**Re: Estrella Substation and Paso Robles Area Reinforcement Project (A.17-01-023) –  
Response of NextEra Energy Transmission West, LLC and Pacific Gas and Electric  
Company to September 28, 2017 Letter**

## Response to Deficiency List No. 3

PEA Figure 2-5c. Estrella Speculative Ultimate Substation Ownership

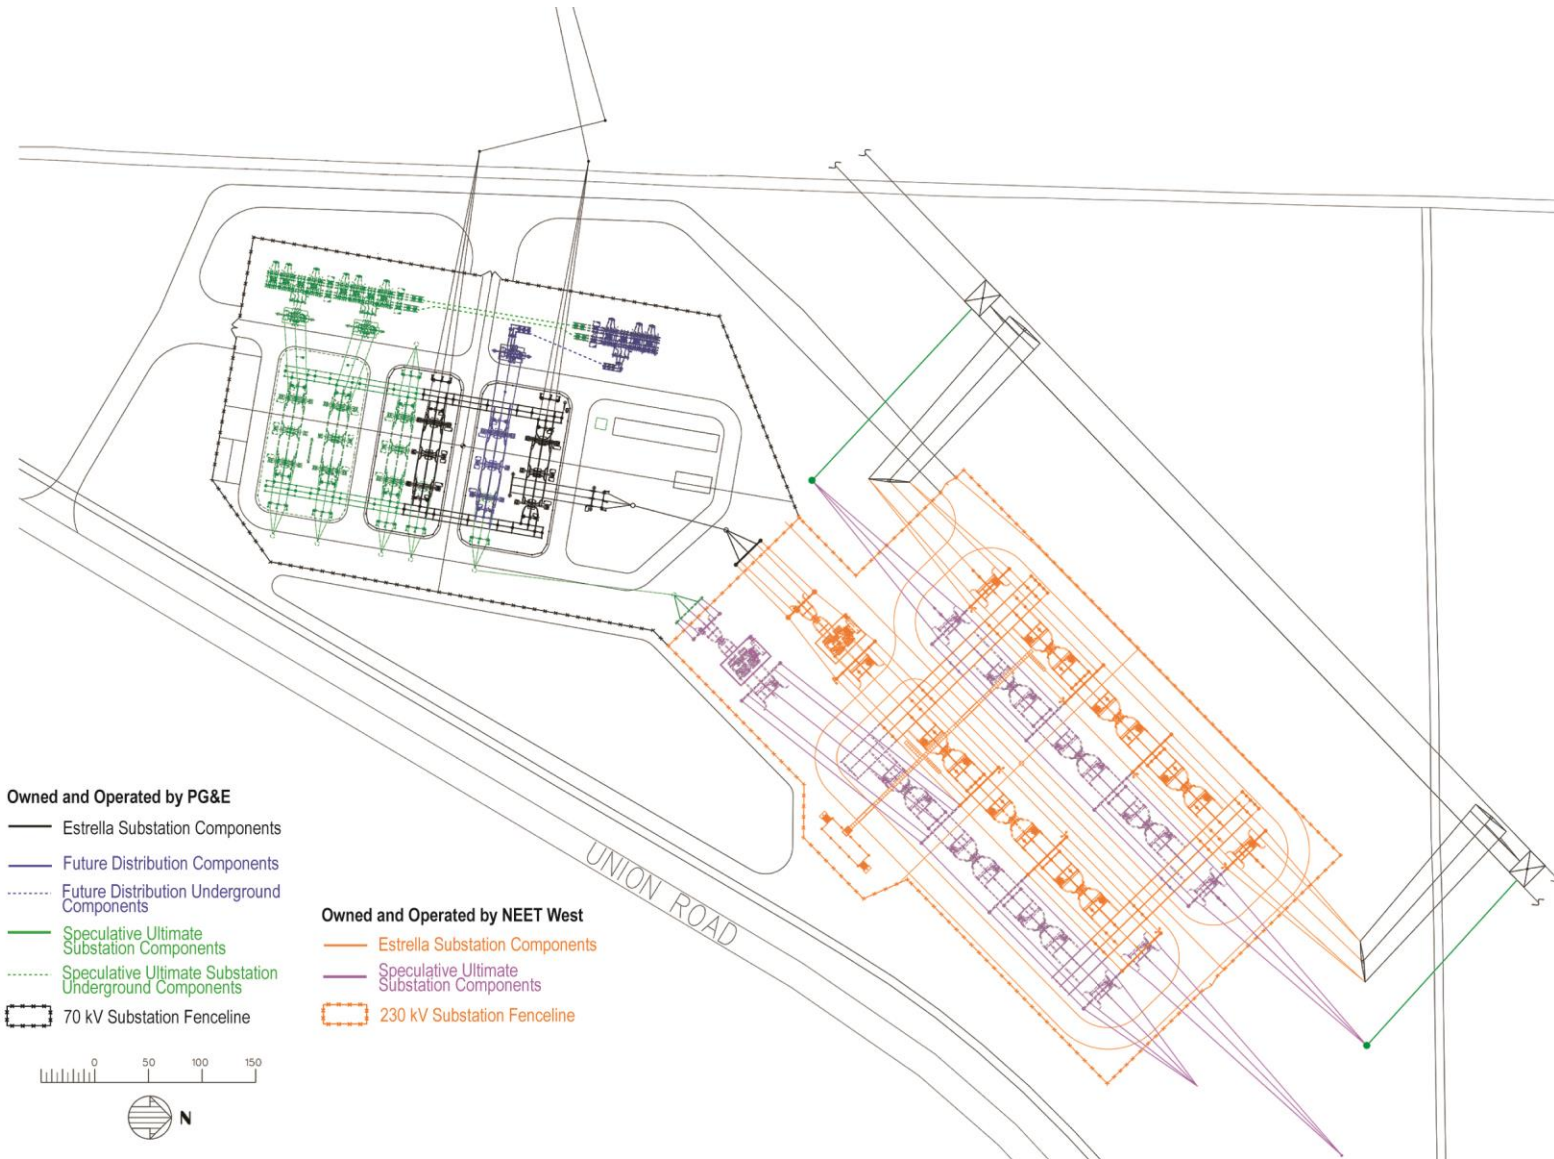
*Identify facility ownership in the future buildout on Figure 2-5b. If PG&E would own the items within PG&E's fence line, use a light blue instead of green to make this clear.*

*Clarify whether each facility company would own all components within their respective fence lines. If this is not the case, use color to show, clearly, which components would be owned by NextEra and which components would be owned by PG&E. A footnote may be added to the figure if the use of colors is not sufficient to make the figure clear but please try to use color to the extent possible.*

New PEA Figure 2-5c clarifies ownership of the substation components using colors. PEA Figure 2-5b was not updated in order to maintain consistency with other PEA project description figures (PEA Figures 2-5a, 2-5b, 2-6a, 2-6b, 2-7a, 2-7b, 2-8a, 2-8b, 2-9, and 2-10).

**Figure 4. Future Estrella Substation Distribution System**

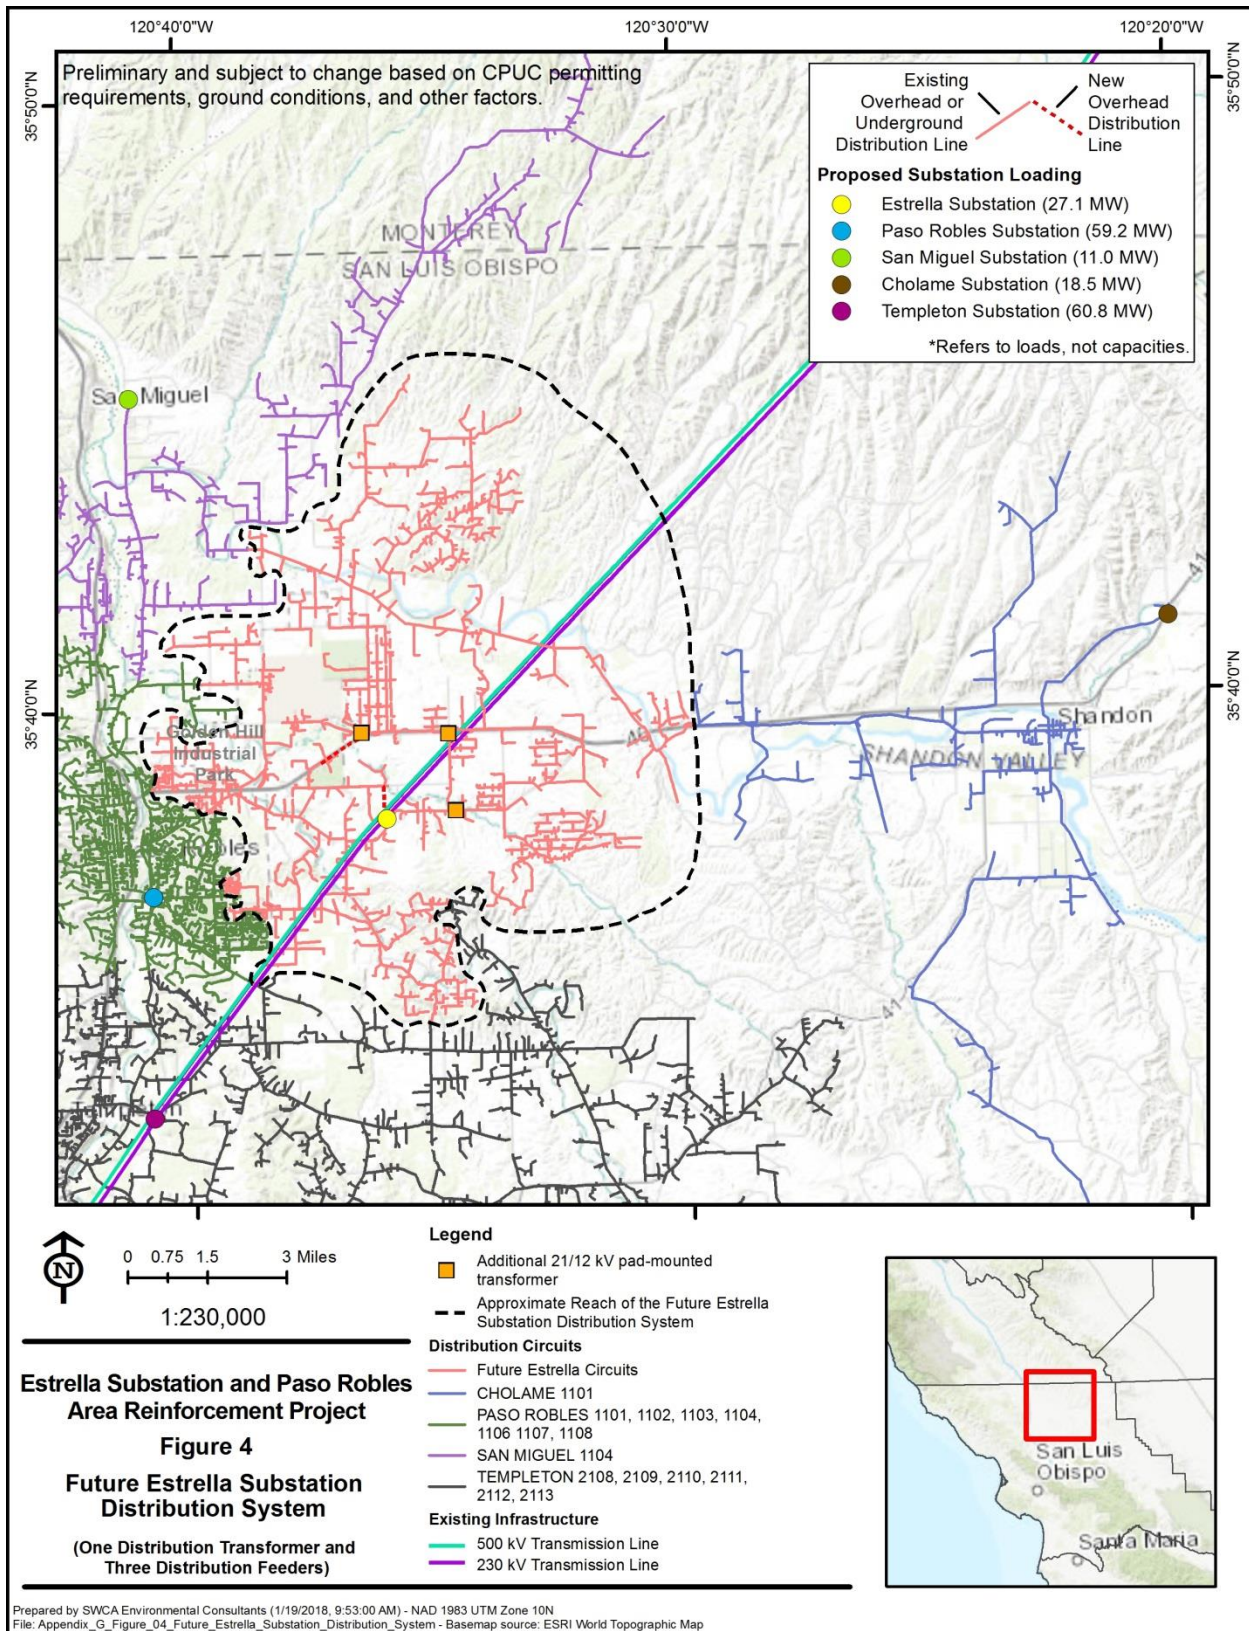
*Please provide a one-line diagram and location map as well. Please provide details of how feeders from the proposed Estrella Substation would re-connect to the existing feeders and distribution points. Include powerflow data for 230-kV system serving the area.*

*Substation. Provide a map showing each of the seven locations. GIS data is preferred with the caveat that the precise location (e.g., which side of the street) may not yet be known at this time.*

- a. Load flow information is not being provided at this time. Figure 4 in the Updated Appendix G provides a location map and one-line diagram. Section II.C provides details of how feeders from the proposed Estrella Substation will re-connect to the existing feeders and distribution points.
- b. Section V.B in the Updated Appendix G provides a discussion of the difficulty of supporting the potential feeder overloads from Templeton Substation to the south.
- c. This information is not yet available.

The response to Deficiency G (9) from Deficiency Letter No. 2 has been incorporated into Section I.A and Section V.B in the Updated Appendix G, as requested under deficiency item G (1.1). Figure 4 in the Updated Appendix G provides the locations of the three additional pad-mounted transformers for the proposed Estrella Substation. GIS data for the transformer locations will be provided in electronic format. Information on the Templeton alternative is not yet available.

- a. GIS for the road centerlines for the new overhead distribution lines identified on Figure 4 in the Updated Appendix G will be provided in electronic format.
- b. No additional response requested.
- c. No additional response requested.

**Figure 5. Updated LoadSEER Forecast, Paso Robles DPA**

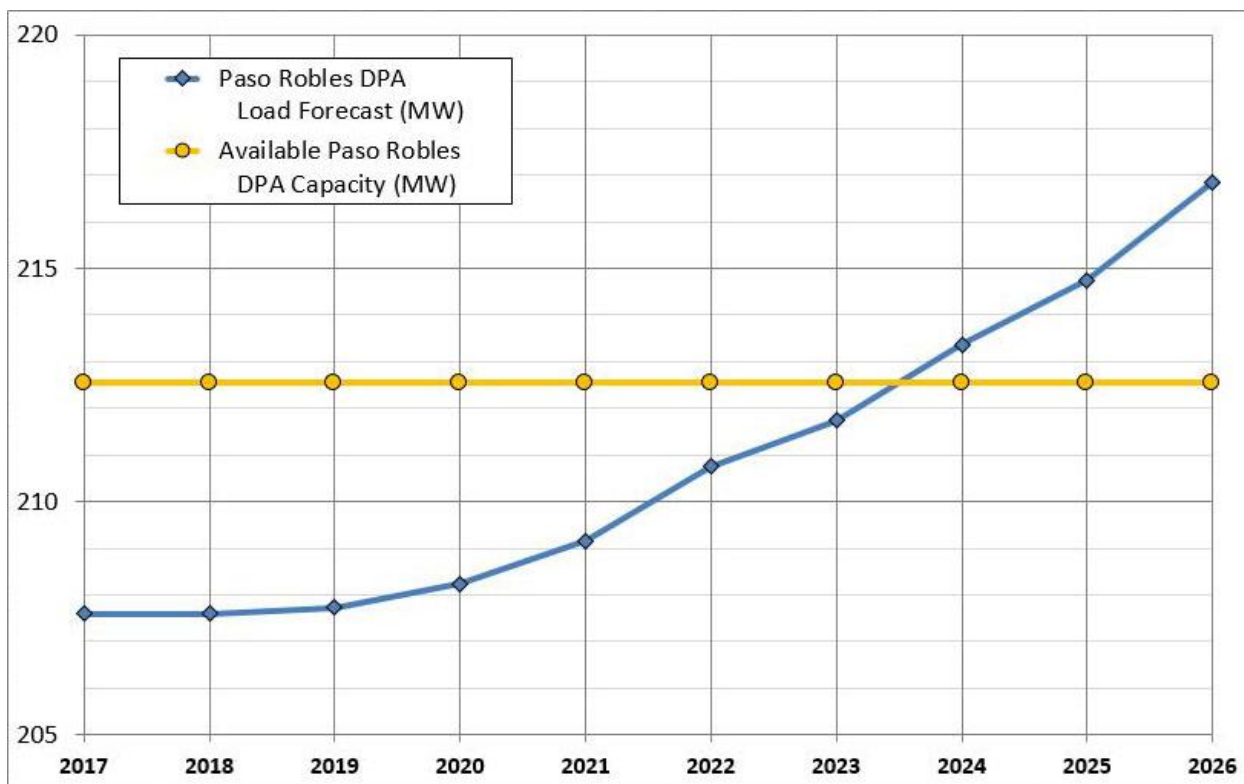
- b. *Provide the step-by-step methodology used for deriving the updated load growth curve in Figure 5 of the Updated, August 2017, PEA Appendix G. Include the methodology used to determine the reduction in assumed solar PV. Please provide an accompanying table*

*showing the load components (i.e. initial IEPR forecast figure, assumed DERs, New Loads, etc.) which should sum to the given year's total LoadSEER Forecast.*

- a. Section III.B in the Updated Appendix G describes the adjustments PG&E made to the Integrated Energy Policy Report (IEPR) forecast.
- b. Section III.B in the Updated Appendix G provides the step-by-step methodology used for deriving the updated load growth curve in Figure 5 of the August 2017 version of Appendix G, as well as the methodology used to determine reduction in assumed solar photovoltaic (PV). Table 3 in the Updated Appendix G shows the load components.

**Figure 6. Comparison of LoadSEER Forecasts, Paso Robles DPA<sup>5</sup>**

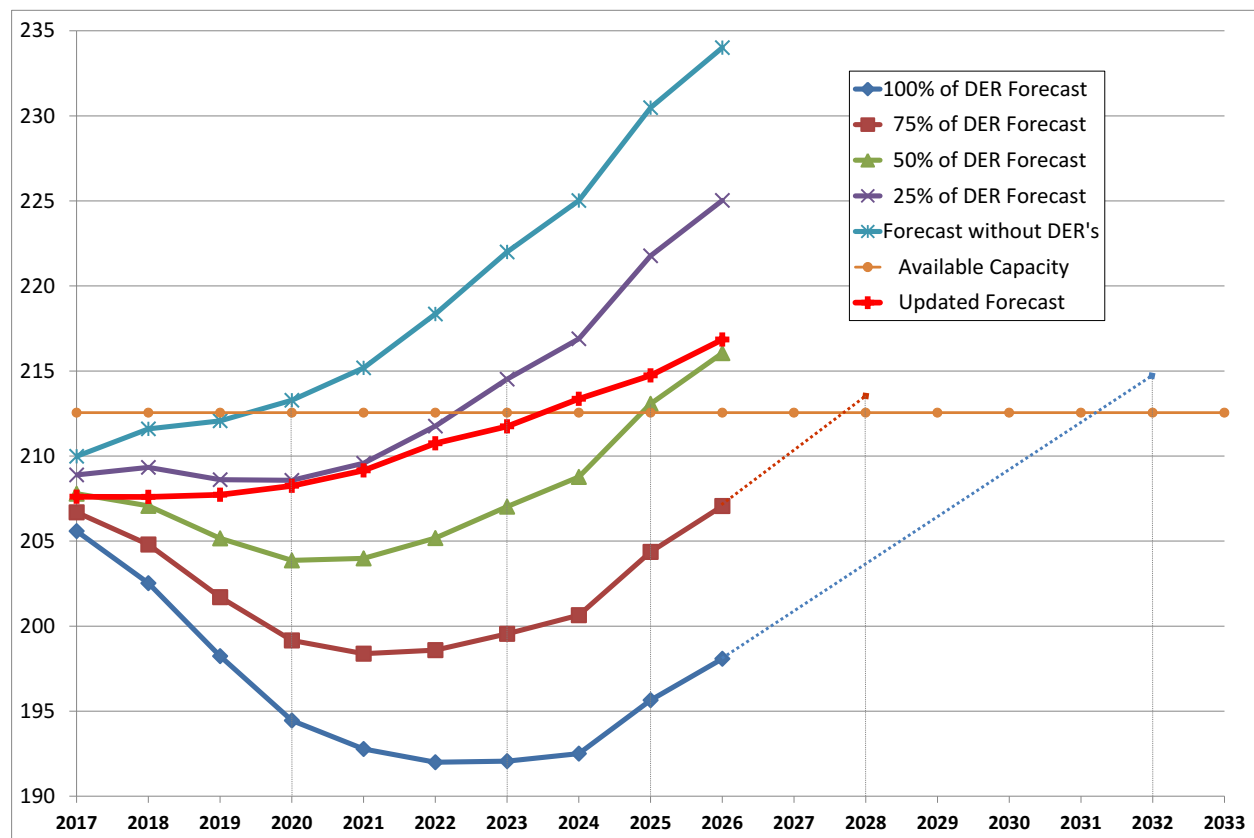
- c. Please plot the new load forecast curve against the now removed May 2017, Appendix G, Figure 5, which showed the increments of DER forecasts under the "prior" DRP methodology. This will allow for visual comparison of the May 2017 Appendix G results and August 2017 Appendix G results.*

*Please respond to the prior deficiency item (6/29/17; item G 12 a and b) and update the text in Appendix G accordingly with the response. The prior (May 2017) Figure 5 and Table 2 must be included in the requested Appendix G update (Def. Letter No. 3). The prior results (May 2017) must be compared to the new results in the refiled update to Appendix G.*

- c. Figure 6 in the Updated Appendix G plots the new load forecast curve against the increments of distributed energy resources (DER) forecasts under the prior Distribution Resource Plan (DRP) methodology.

Figure 6 and Footnote 5 provide the requested information.

**Figure 7. Future Estrella Substation Distribution System, Large-Load Adjustments, and Future Load Centers**

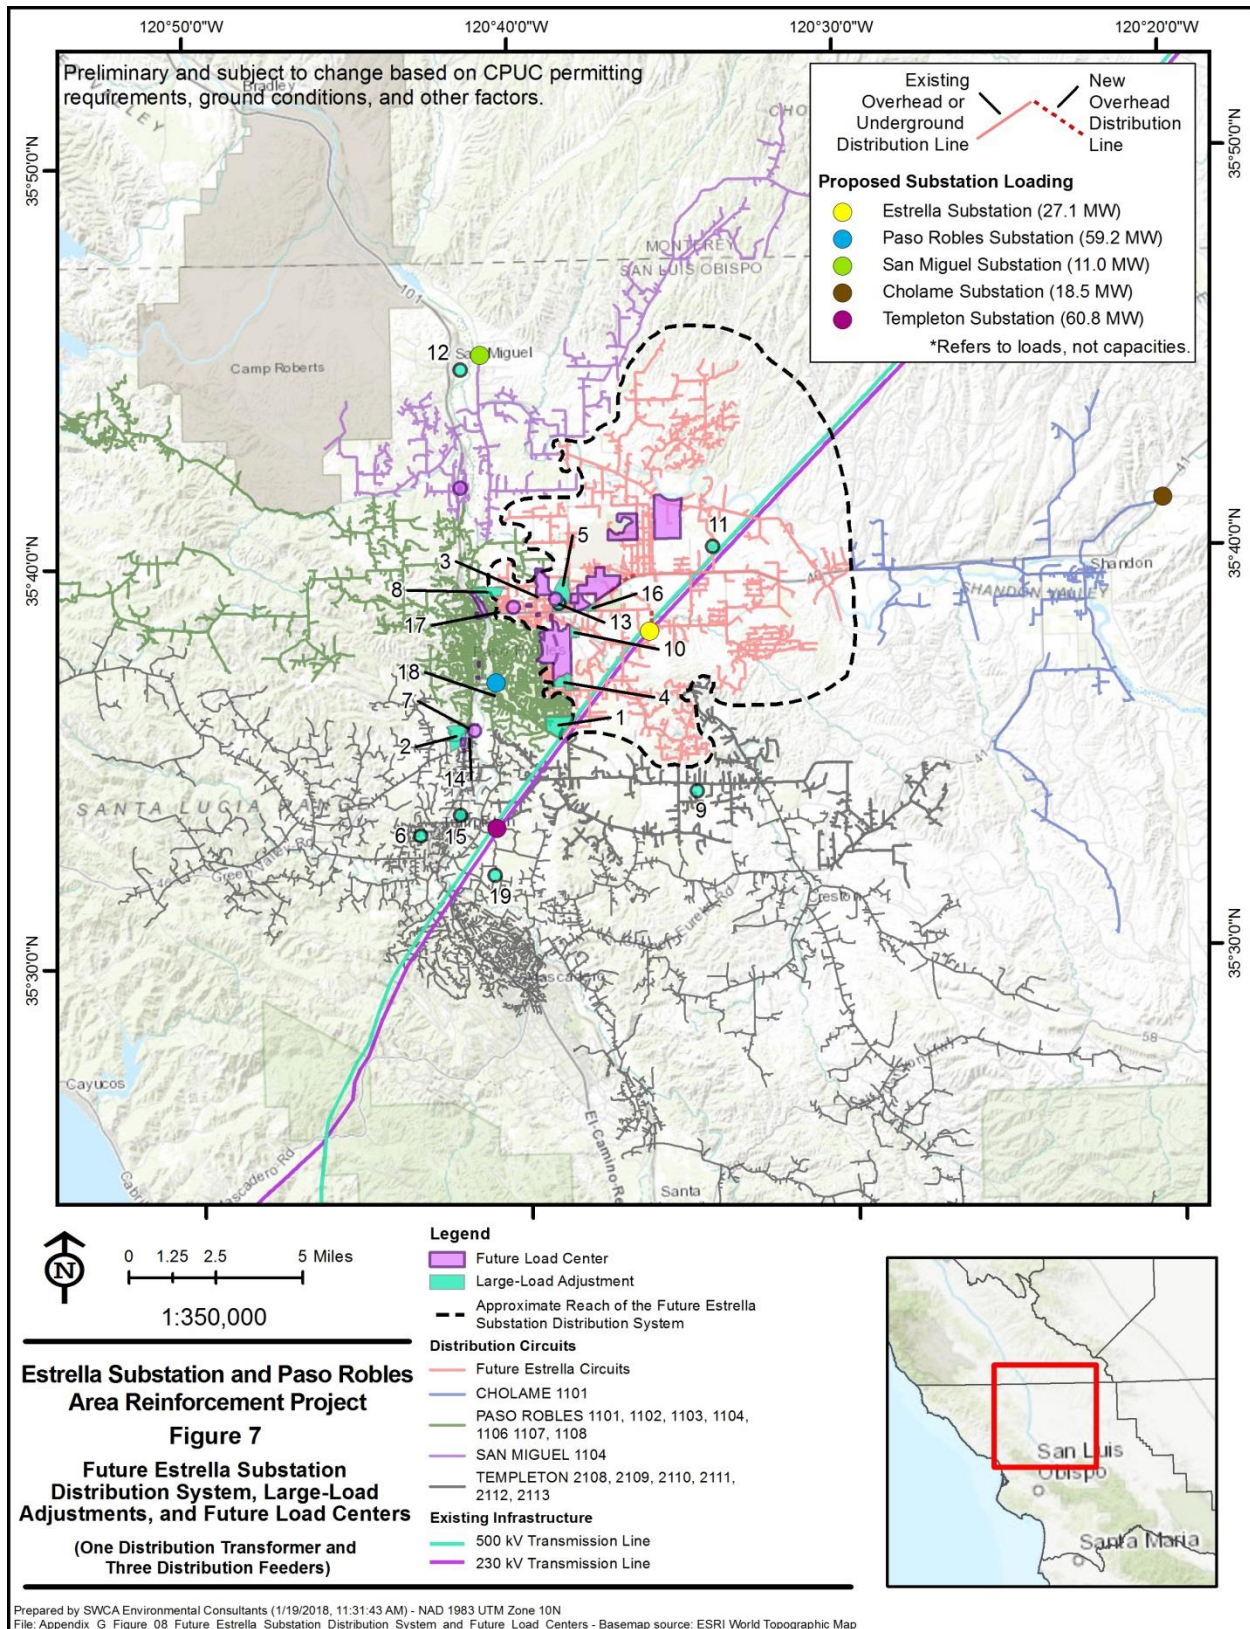
*The August 2017 Appendix G, Figure 7 shows the locations of Future Load Centers. If so, provide an updated Figure that labels the Future Load Centers with the Large-Load Adjustments from Table 3.*

*In addition, please add two columns to Table 3, “Year Received/Approved” and “Expected Completion Date.” Use “Approved YEAR” if already approved or just list “Received YEAR.” Label each item with an ID letter or number and insert the ID onto Figure 7 (Future Estrella load centers).*

Figure 7 has been updated as requested. Table 6 and Figure 7 in the Updated Appendix G indicate the large-load adjustments that were made to the IEPR forecast. Footnote 4 explains why distribution generation interconnections were not included as adjustments to the IEPR forecast. The “Project Identification Number,” “Year Received/Approved,” and “Expected Completion Date” columns for these adjustments were added to Table 6, and the corresponding locations were labeled with the project identification numbers in Figure 7. Table 8 lists past and future known solar projects connecting into the Paso Robles DPA.
